Initial Funding Request Form

Date Prepared: 03/08/2021	Project Title: IRU Dark Fiber
Company/ies: Eversource NH	Project Number: A21N46
Organization: Substation Technical Engineering	Class(es) of Plant: Telecom
Project Initiator: Cory Wess	Project Category: Stations - Telecommunications
Project Manager: Todd Kopoyan	Project Type: Specific
Project Sponsor: Roderic Kalbfleisch	Project Purpose: Enable P&C Projects / Compliance
Estimated in service date: 11/01/21	If Transmission Project (check all that apply): PTF <input type="checkbox"/> Non-PTF <input checked="" type="checkbox"/>
Authorization Type: Initial Funding	
Total Request: \$35,000

PSNH dba Eversource Energy
Docket No. DE 20-161
Least Cost Integrated Resource Plan
March 31, 2021 Supplement
Appendix F-23
Page 3 of 3

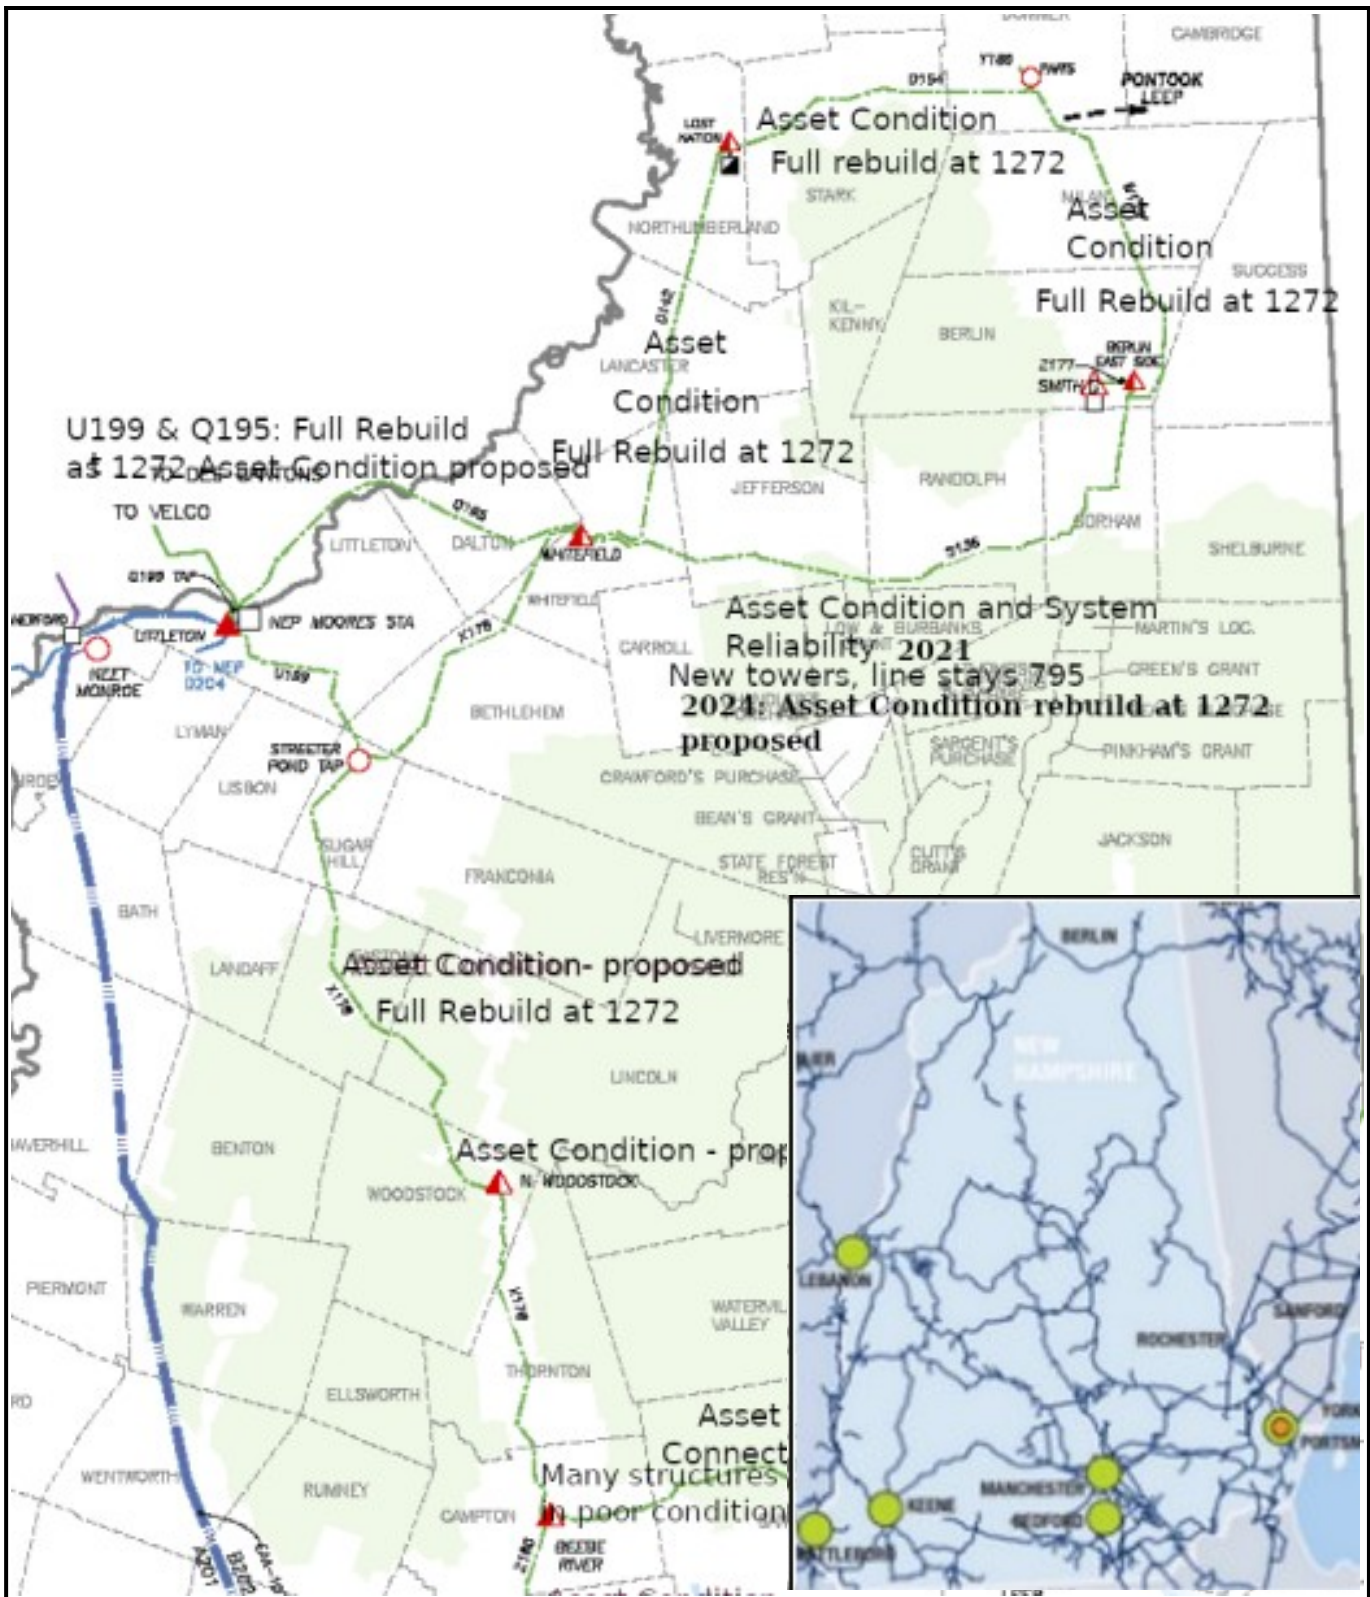
Did this project happen? Inset shows most of FirstLight's network in New Hampshire.
